TECHNICAL MEMORANDUM

PEER REVIEW OF SACRAMENTO VALLEY FINITE ELEMENT GROUNDWATER MODEL (SACFEM)

U.S. Bureau of Reclamation

October 2011

Figure 2. SacFEM Grid

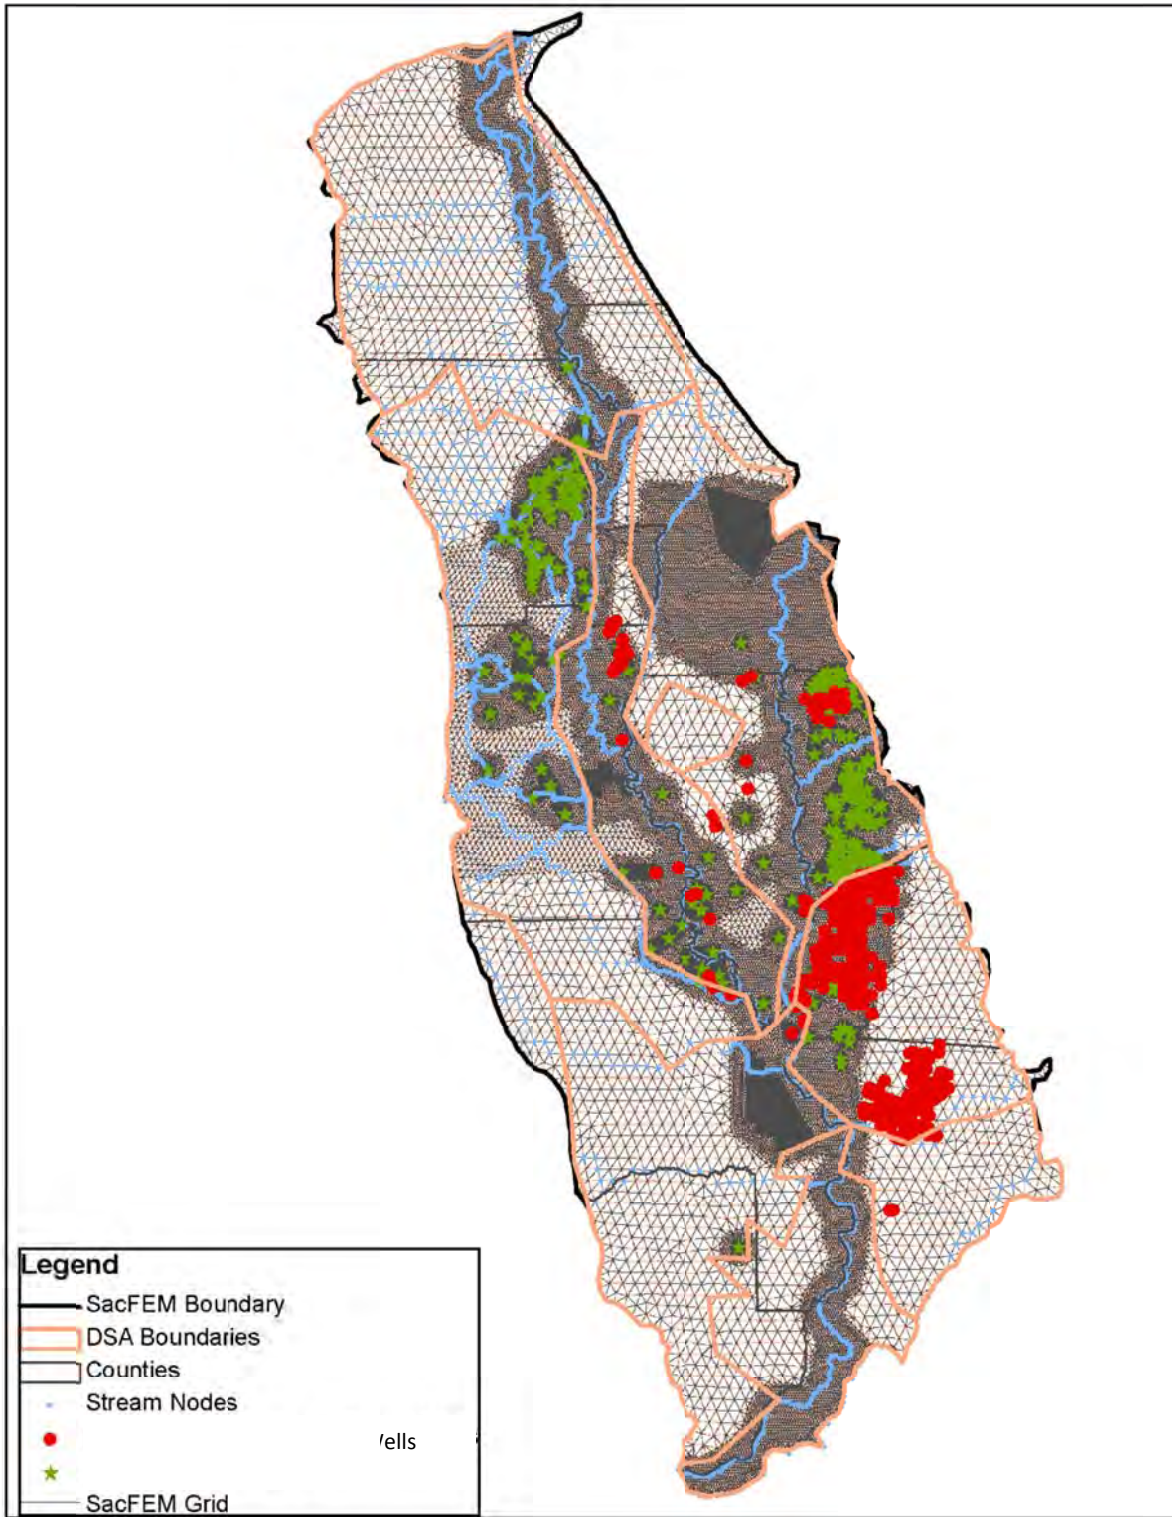
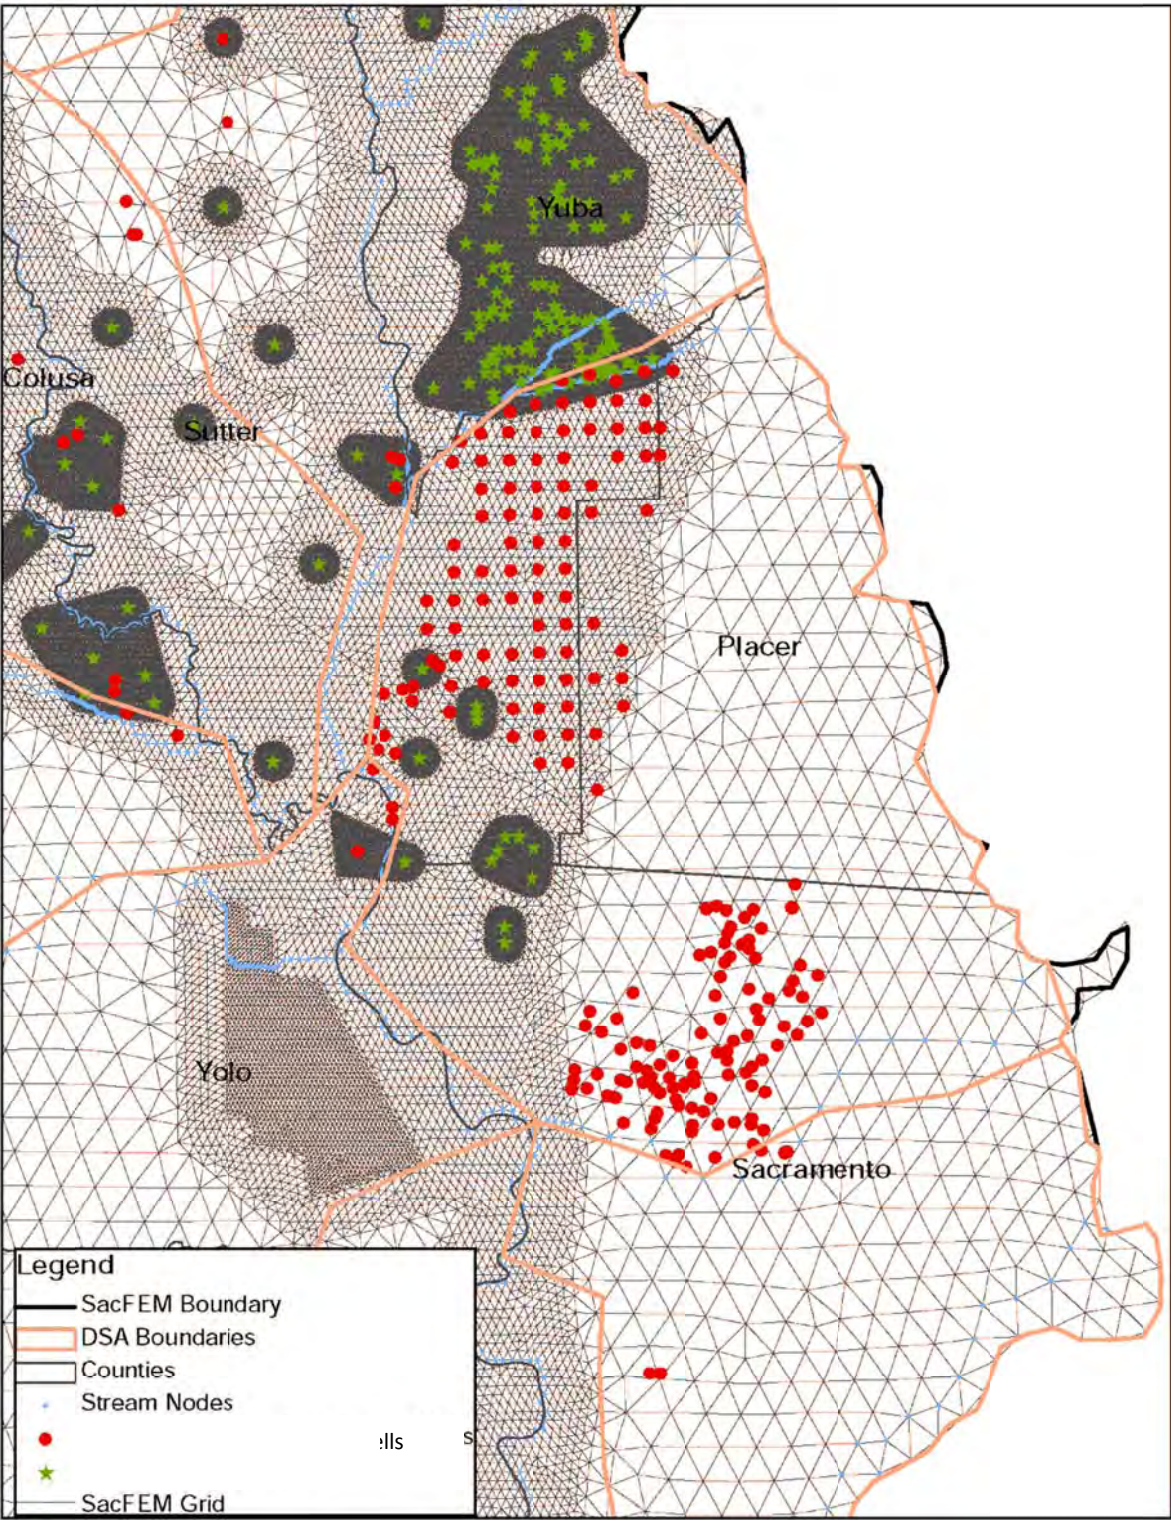
The SacFEM grid was configured to support evaluation of potential conjunctive water management projects associated with the SVWMP. It consists of 120,761 nodes and 241,001 elements (Figure 2). Nodal spacing varies from 325 feet (ft) to 8,200 ft. Finer node spacing is used near most of proposed project areas, project well pumping areas, and major rivers (Figure 3).

A comparison of SVWMP and the 2009 Drought Water Bank project wells locations with the SacFEM grid indicate that most project wells are located in the fine node spacing parts of the grid (Figures 2 and 3). However, Water Bank project wells in Sacramento County, east of Highway 50, are located in the coarse node spacing part of the grid (Figure 3). The coarser node spacing in this area does not support refined estimates of the effects of the Water Bank project in the Sacramento area. Project wells in the Sacramento area are recommended to be excluded, or the SacFEM grid needs to be refined in the Sacramento area for evaluation of the impact of conjunctive use projects.

1. The grid is well sized for most project areas, other than the Sacramento area.

1. **Refined Grid in Sacramento County** – SacFEM does not represent projects in the Sacramento area with refined grid. Refined grid should be used for this area, should SacFEM be used for project analysis in Sacramento County.

Figure 4. 2005 Land Use

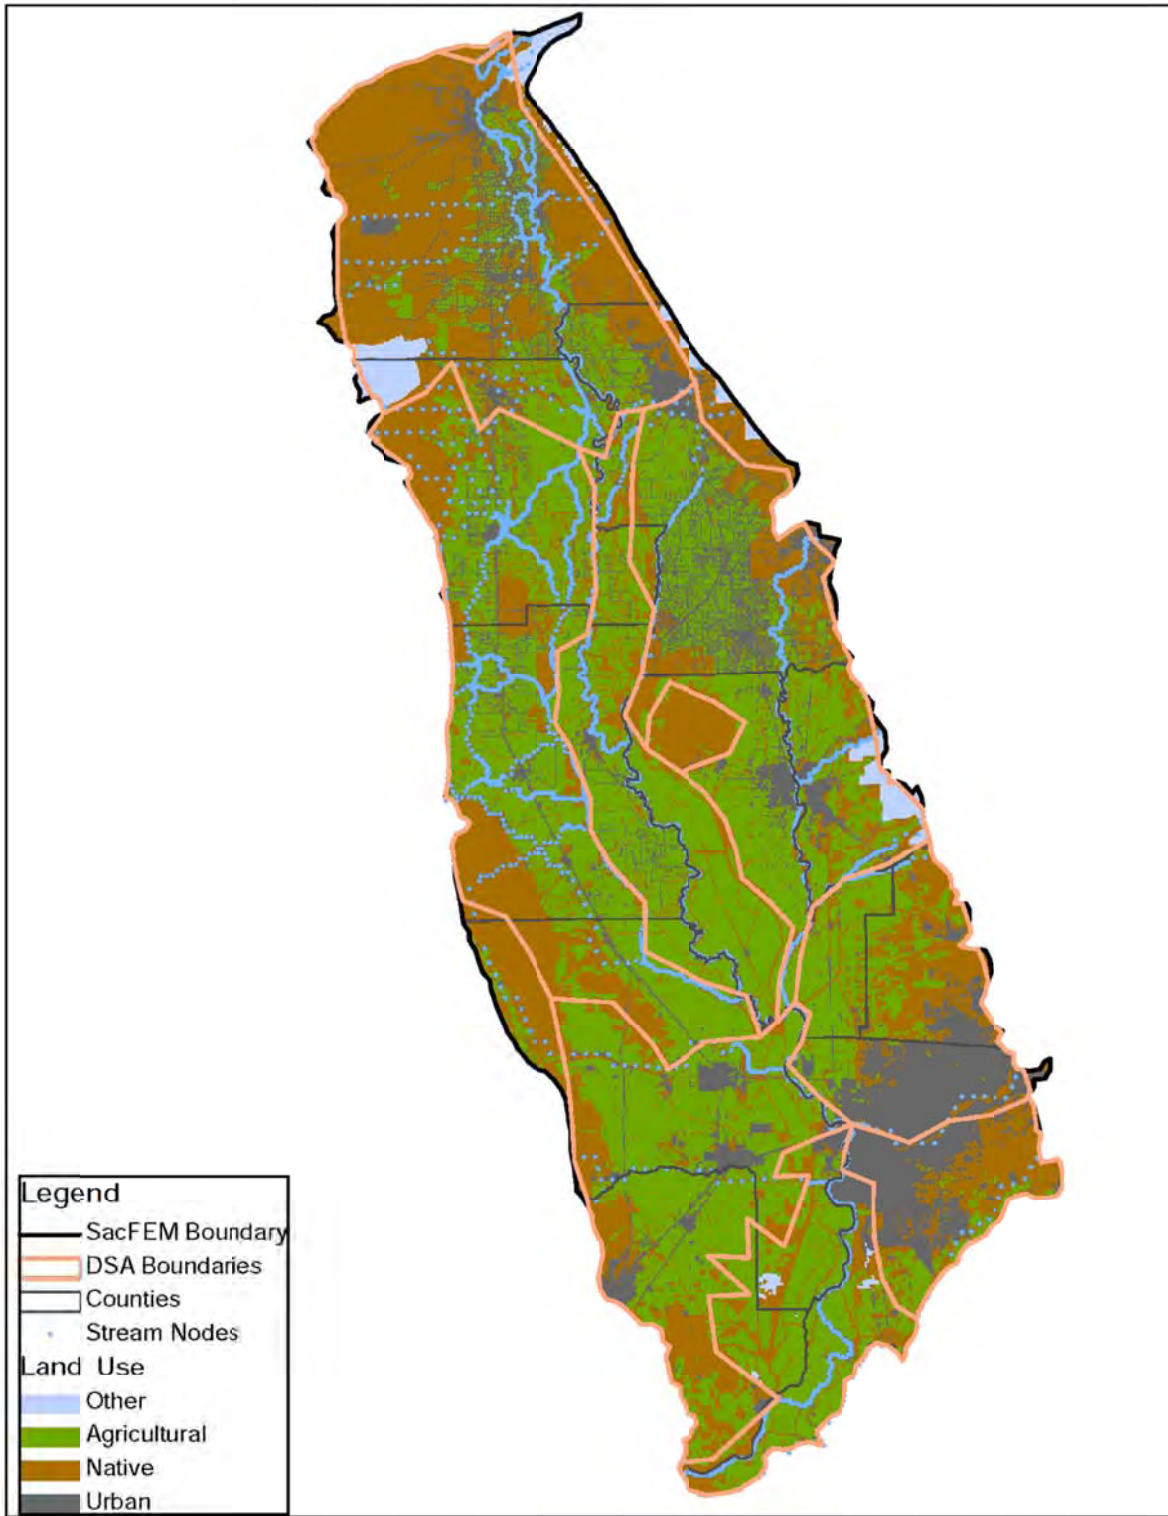
SacFEM and the IDC model use land use data for estimation of groundwater pumping and deep percolation during the 1970-2003 calibration period (Figure 4). The land use and cropping data are from DWR field surveys from several different years spanning from 1994 through 2003 (Table 1), and are assumed to represent approximately the 2005 level of development. It is assumed that no significant land use changes have occurred during the 1970-2003 period. However, other historical land use survey data are available from DWR for 1967, 1980, 1993, and 2000.

The use of only the 2005 level of development results in mismatch of the long-term changes in groundwater elevations in several calibration wells. The increase in urban areas will result in changes in groundwater pumping and elevation. This is evident in simulated groundwater elevations in calibration wells in the vicinity of the cities of Sacramento, Woodland, and Chico.

Additional historical land use information is recommended to be used for SacFEM and the IDC model to improve model calibration and obtain a better match of the long-term trends in groundwater elevation. Historical land use is not needed for analyzing the proposed projects; however, if SacFEM is better calibrated, it will have an improved estimate of the effects of the conjunctive use projects.

Figure 5. 2005 Crop Acreage

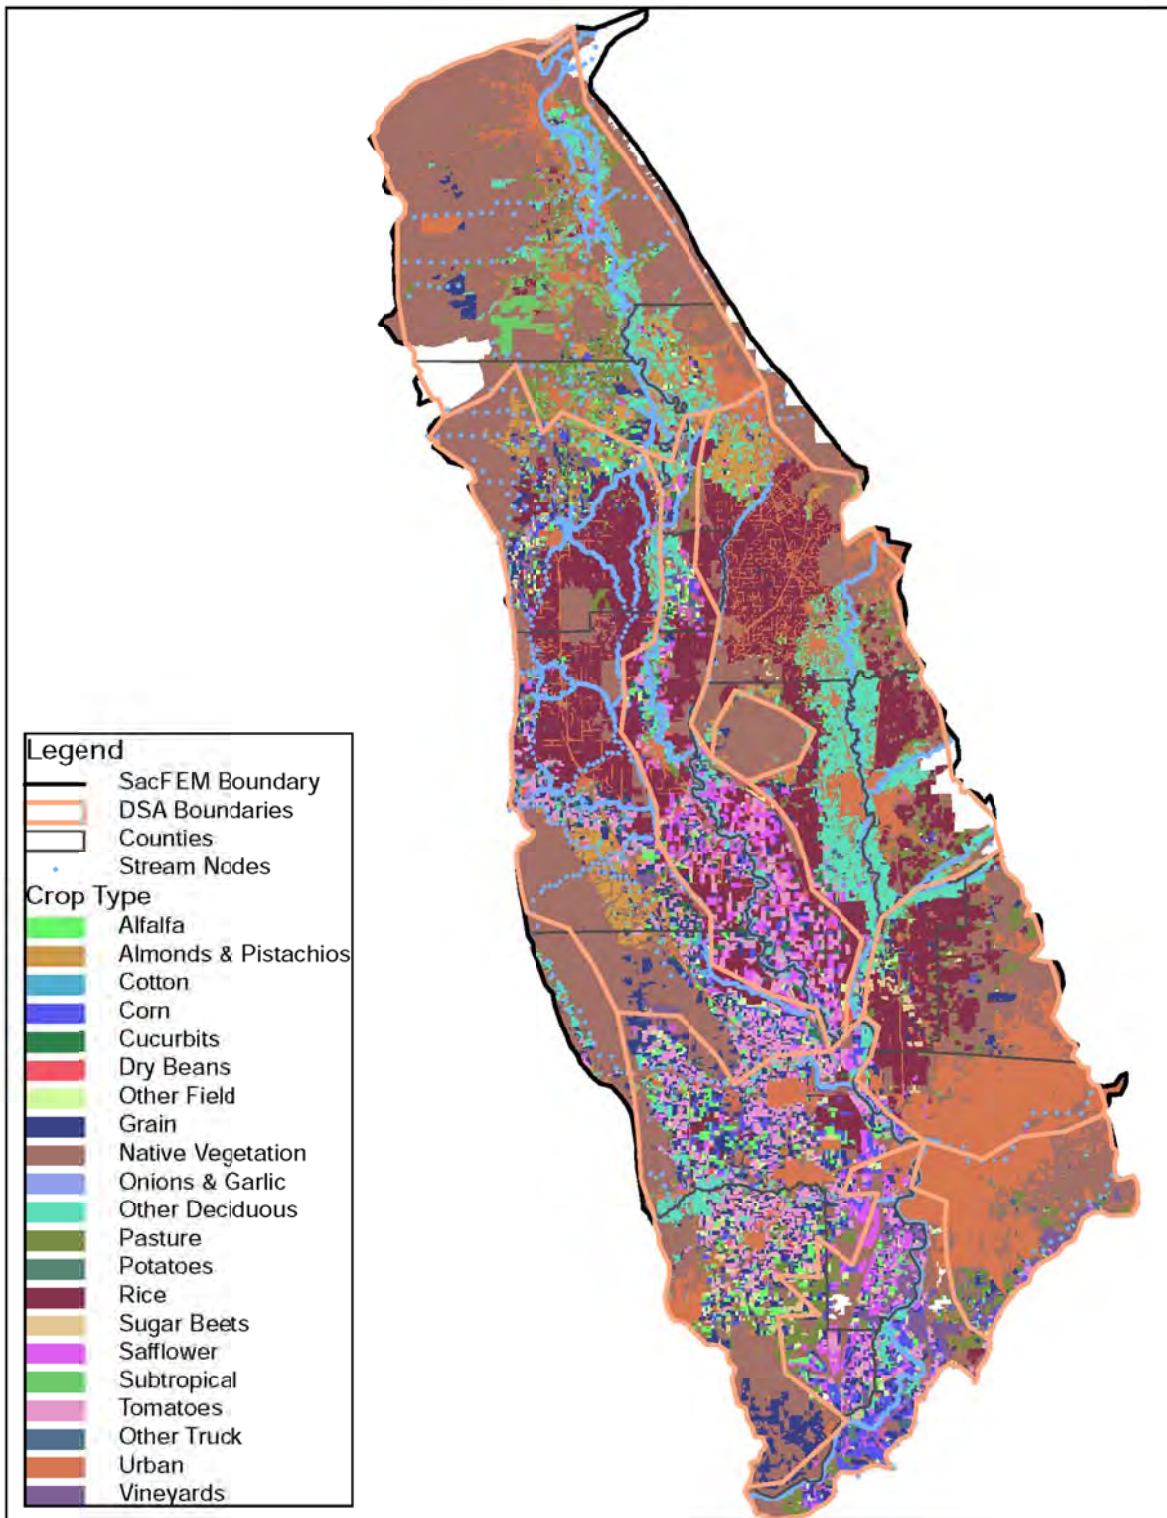
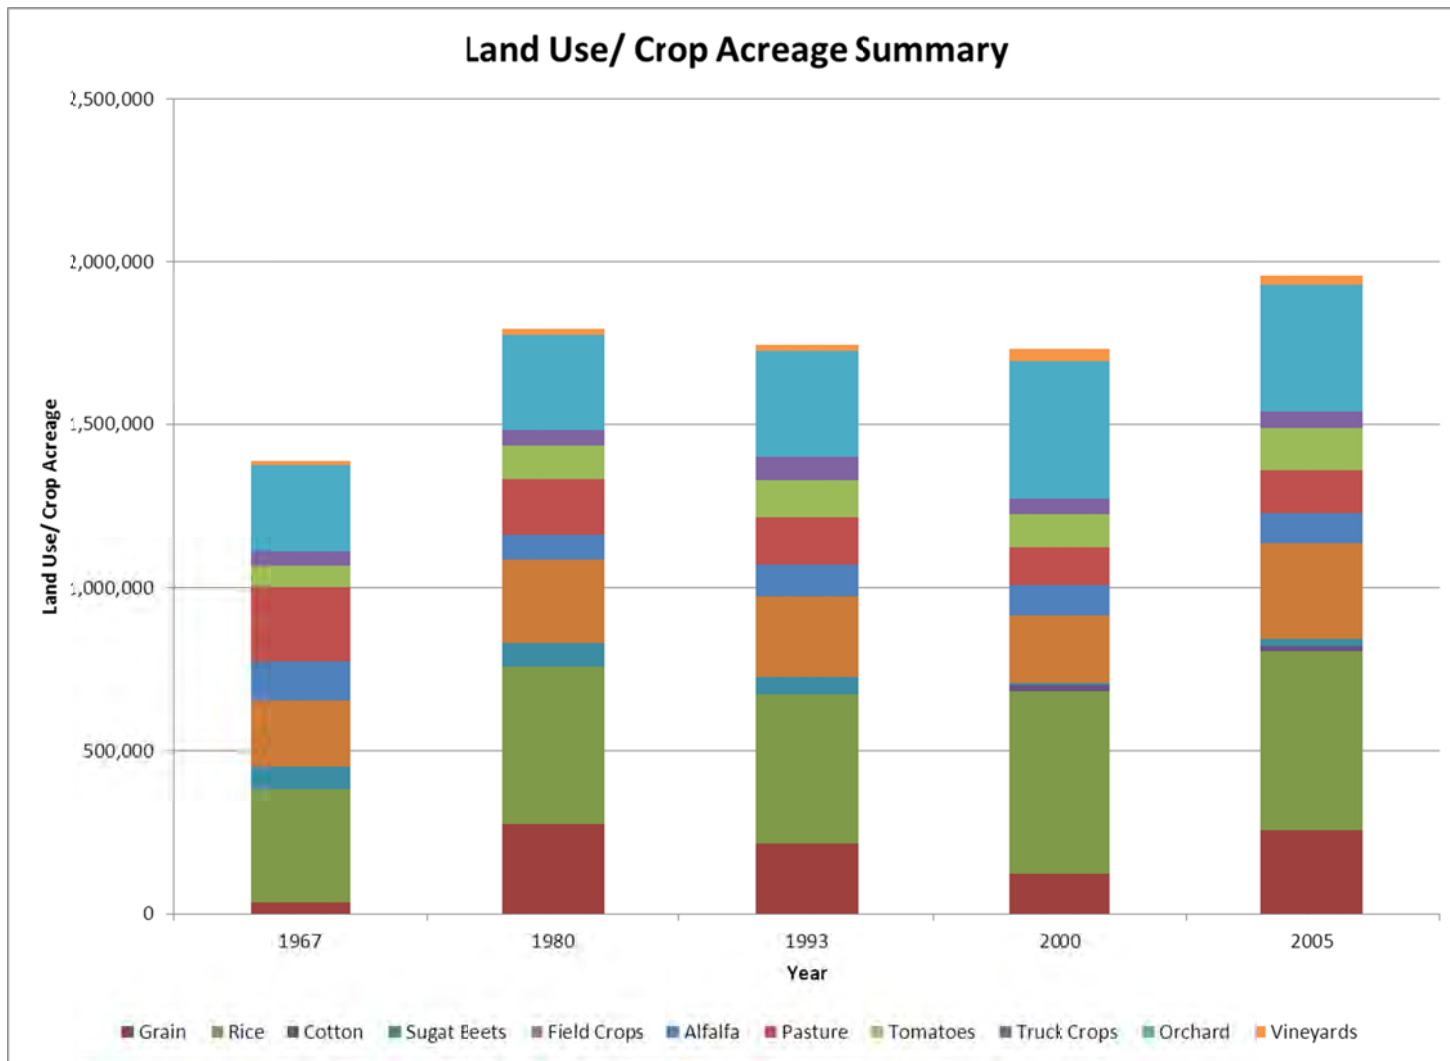
SacFEM and the IDC model use only the 2005 level of development crop mix data for the 1970-2003 calibration period (Figure 5). Similar to land use data, it is assumed that no significant changes to crop acreages have occurred during this period. Other historical land use survey and crop acreage data are available for 1967, 1980, 1993, and 2000. Figure 6 and Table 2 compare crop acreages and crop mix distribution of the Central Valley Groundwater and Surface Water Simulation Model (C2VSIM) with SacFEM crop acreage data. Alfalfa and pasture acreage reduced from a total of 25.1% in 1967 to 11.4% in 2005. Rice acreage varied from 25.2% in 1967 to 32.3% in 2000. Orchard acreage varied from 16.4% in 1980 to 24.4% in 1993.

Historical land use and cropping patterns for 1970-2003 indicate major changes in crop mix over time. These changes affect the historical estimates of agricultural water demand, agricultural groundwater pumping, and deep percolation. It is recommended to use historical crop acreage data for improved calibration of SacFEM and IDC models. A better calibrated SacFEM will have an improved estimate of the long-term trends in groundwater elevation as a result of future conjunctive use projects.

1. **Include Historical Land Use and Crop Mix Data** - SacFEM calibration does not include historical land use and crop mix data. As a result, estimates of agricultural demand, groundwater pumping, and deep percolation for historical period are not representative of historical conditions.
